**ASHLAND PLANNING COMMISSION
REGULAR MEETING
NOVEMBER 9, 2010
AGENDA**

**CITY OF
ASHLAND**
ASHLAND PLANNING COMMISSION
REGULAR MEETING
MINUTES
October 12, 2010

ASHLAND PLANNING DIVISION STAFF REPORT ADDENDUM

PLANNING ACTION: PA-2010-00992

ELEVATIONS

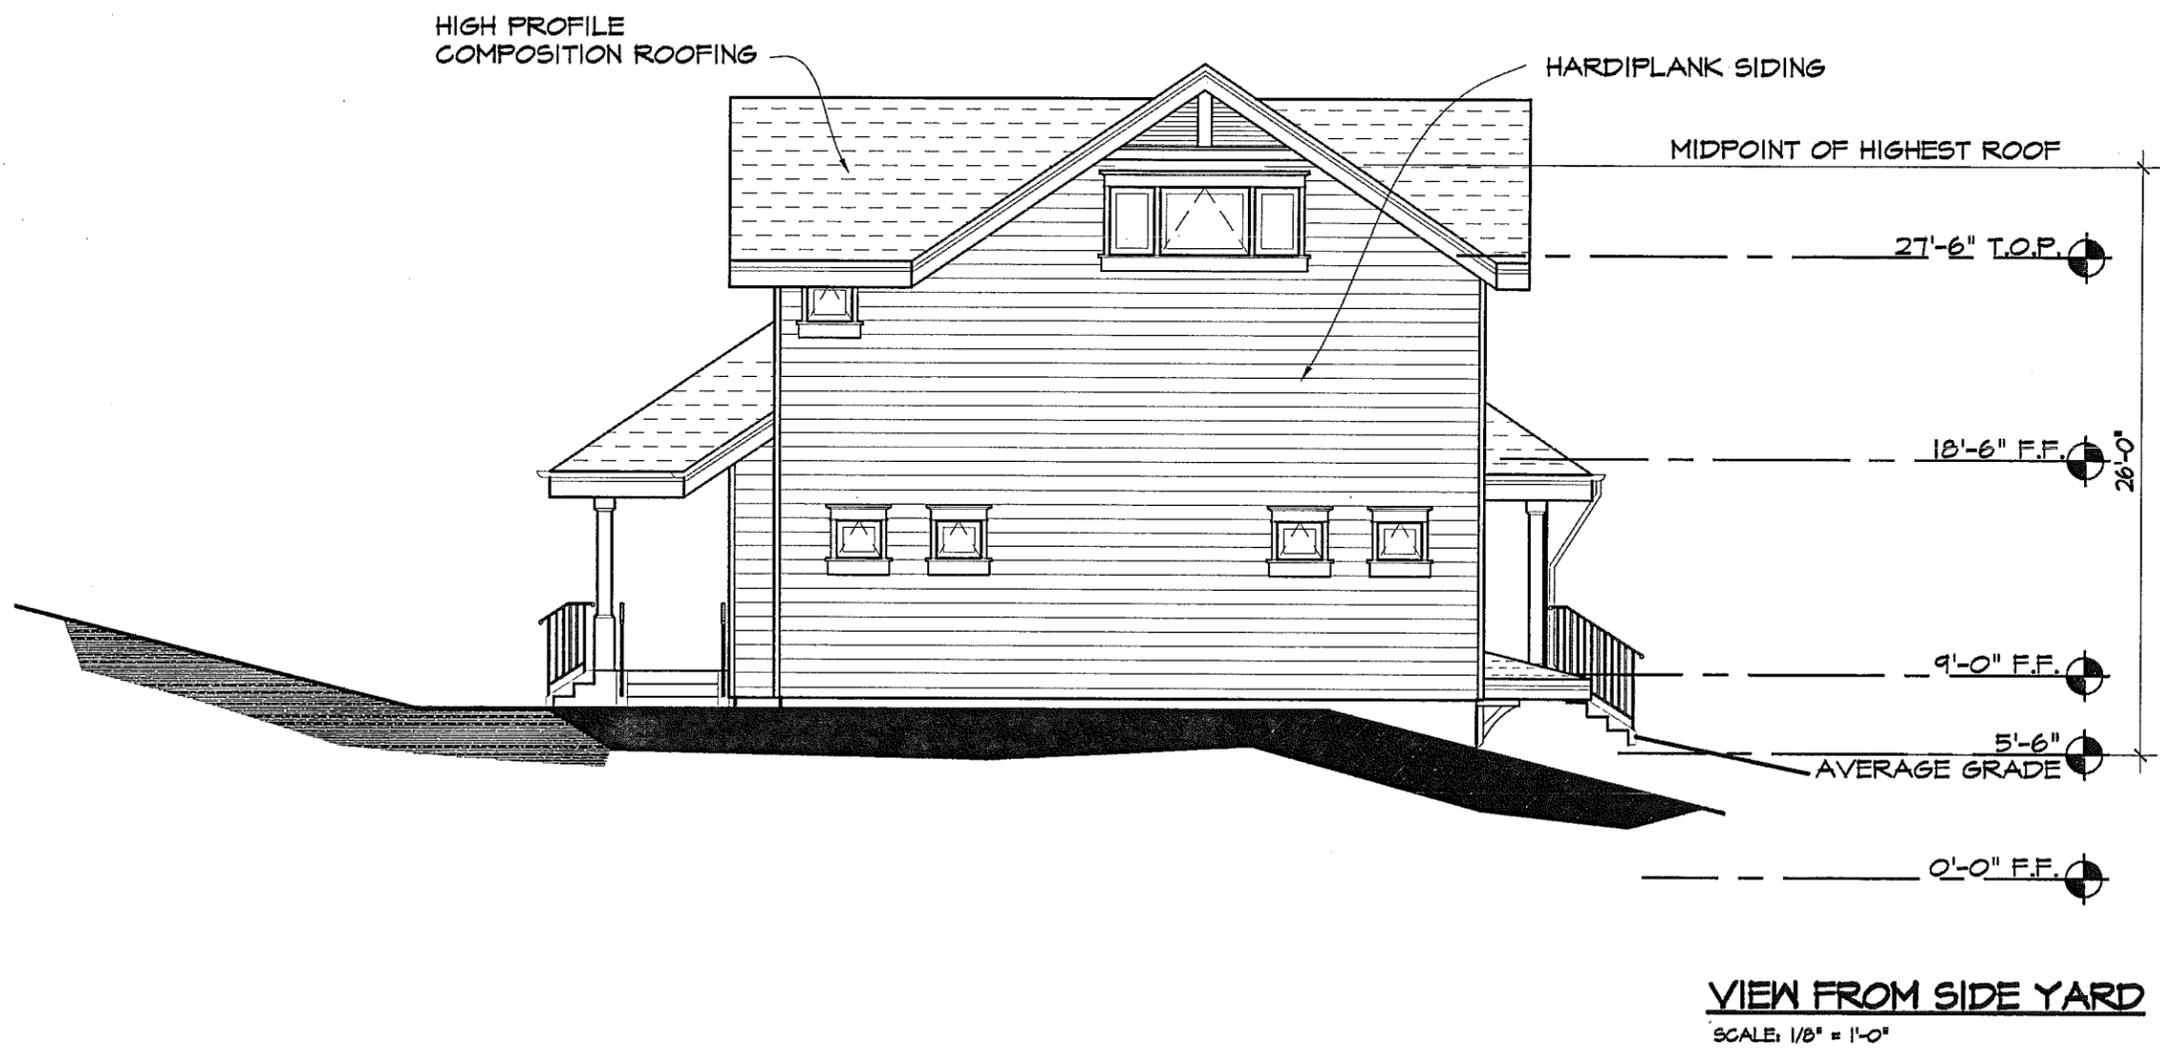
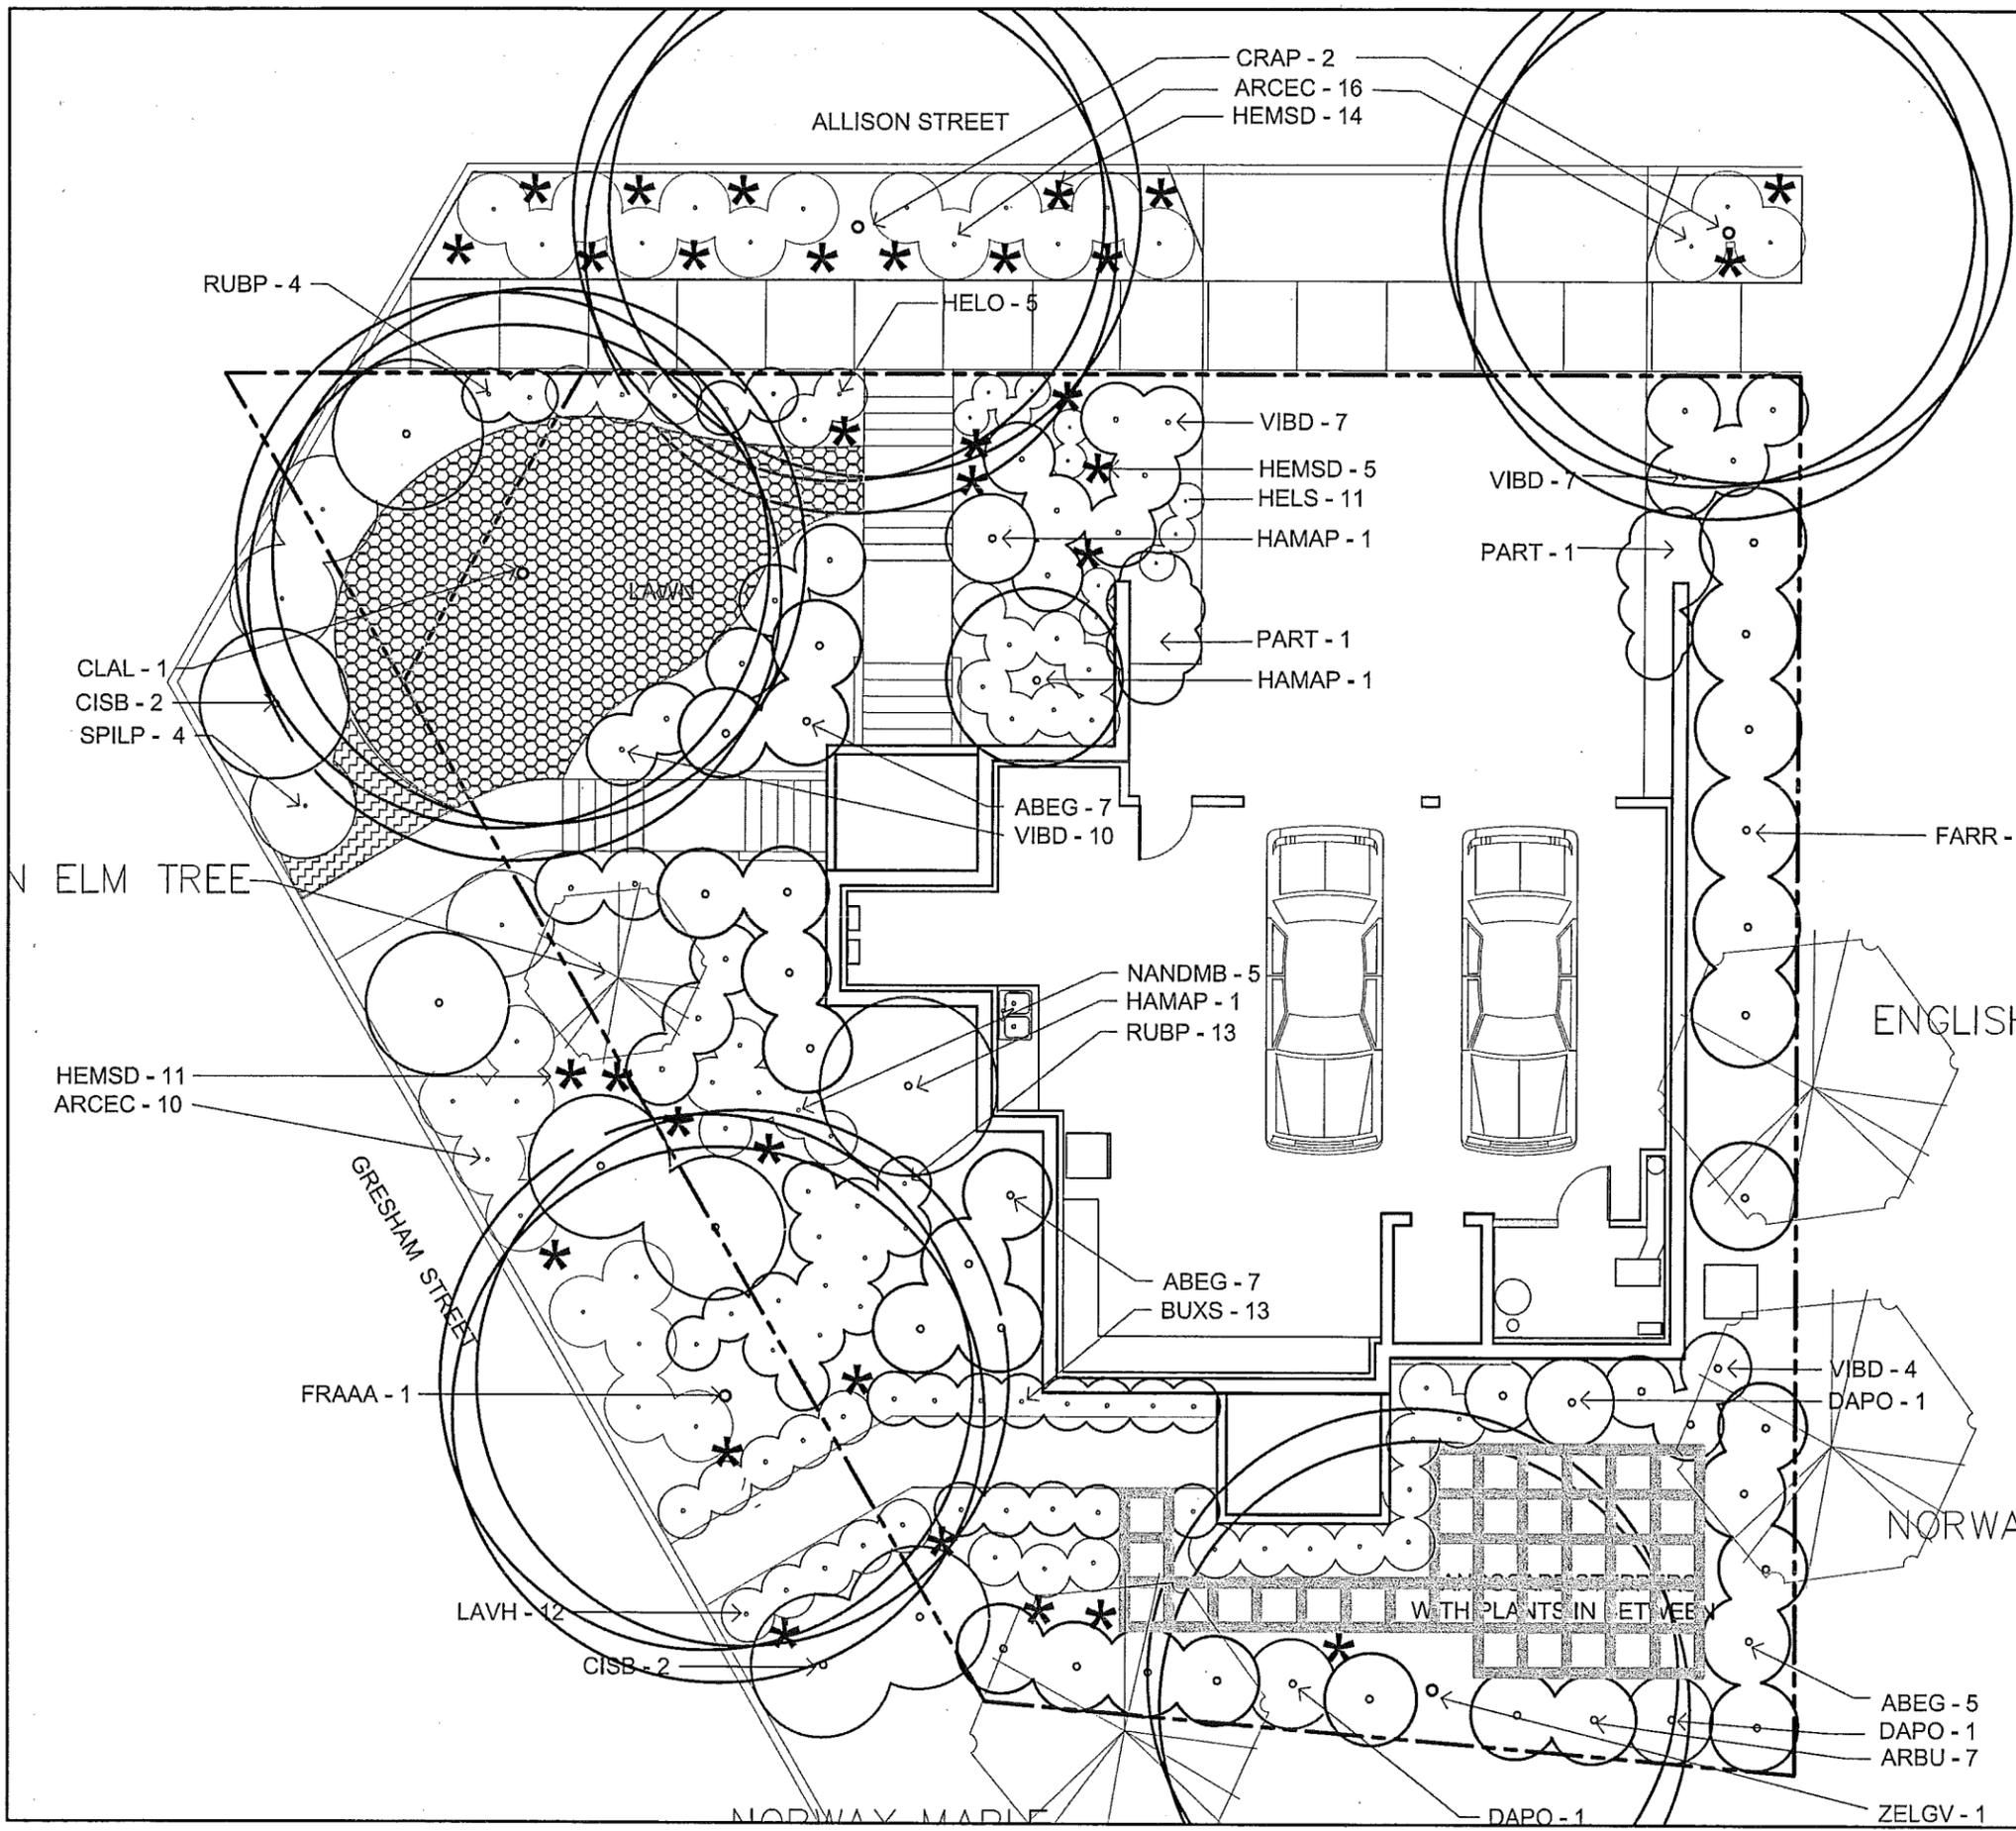
- Request was made for the applicant to address the front of the home on Gresham St., and to have an Allison presence that does not conflict as severely as what is proposed.
- Suggestion was made to perhaps change the orientation and/or height of the gable in order to improve the Allison façade.
- Comment was made that while the owner wishes to have views from his second floor mezzanine, the architect should consider the use of dormers or some other mechanism to provide these views.
- Comment was made that the Allison frontage is awfully tall.

- Comment was made questioning why the octagon shaped kitchen needs to be so tall, and opinion was given this hexagon form on the corner will look out of place.
- Comment was made that the biggest problems with this house is lack of a historically compatible porch and the bulk of the façade facing Allison.
- Suggestion was made for the main entry issue to be corrected.
- Comment was made that the big double garage on Allison totally overwhelms that frontage.

- 1) Concerns with compatibility in terms of mass, bulk, scale and volume as the proposed home had roughly 1,000 square feet of floor area where the average ceiling height approached 24 feet. The Commission noted that if the home were traditionally framed, with more standard ceiling heights, this would have added an additional 1,000 square feet or more of floor area, meaning that the volume proposed was more akin to a 3,200 square foot home on a 4,900 square foot lot than that of a 2,200 square foot home. The turreted kitchen volume had a 12-foot plate height which significantly increased its perceived volume, and the Historic Commission was

- 2) In addition to the larger issues raised above, the Commission also had a number of specific recommendations with regard to design details:
 - a) The Gresham Street entrance needed a stronger sense of presence to give stronger cues for a sense of entry on Gresham. The Commission asked to see side-lights added to the door at this entry and questioned the clustering of utility meters on the most prominent wall and the lack of windows. Commissioners recommended a consistent plate line and additional windows be included in the design.

- b) The windows on the Allison Street façade, over the garage, had too great a ratio of window area to wall surface and gave a very contemporary feeling to this elevation. They indicated that this could have been better addressed with a less gridded placement, more tightly grouping the windows in threes, with a more simplified style and less variation in type (i.e. simple double-hung sashes would be preferred). The Commission noted that a window placement more like that noted on sheet A7.3 with a single casing and one crown over a more tight grouping of three windows would be more compatible. The Commission emphasized that a continuity of window sizes and plate heights was important, and also noted concerns with the pinching of window crowns into the gable.

- c) In terms of trim, the corner boards and casings shown were too narrow to be historically compatible, and more detail of historically-compatible exterior trim was needed.

- **Removal of the hexagonal turret element for the kitchen. The kitchen has been relocated within the home and a more traditional porch added in its place.**

In staff's assessment, the redesign has effectively addressed the areas of concern identified last month by staff, and by the Historic and Planning Commissions. A clearer sense of entry from Allison Street has been articulated, the turret element which both Historic and Planning Commission questioned in terms of its cohesiveness with the overall design has been removed, the window type and pattern has been shifted to a less contemporary arrangement, and with the hiping of the roof the remaining gable over the Allison Street garage entry no longer emphasizes the volume on that frontage.

In staff's view, the proposed redesign has addressed the primary concerns that we raised last month: that the orientation of the gable end of the roof over the garage entry and repetition of similar windows on the gable end seemed counter to the directional expression, sense of entry, and rhythm of openings in the neighborhood and broader district and seemed to add emphasis to the home's mass, bulk and scale on the Allison Street frontage; and that there needed to be a stronger sense of entry for the proposed home. While the current proposal retains a gable over the garage, staff believe that the removal of the turret element, hipping of the roof and modification of the windows have resulted in a design that is more cohesive and which effectively deals with the square footage proposed in a manner compatible with the neighborhood, the district and the design standards.
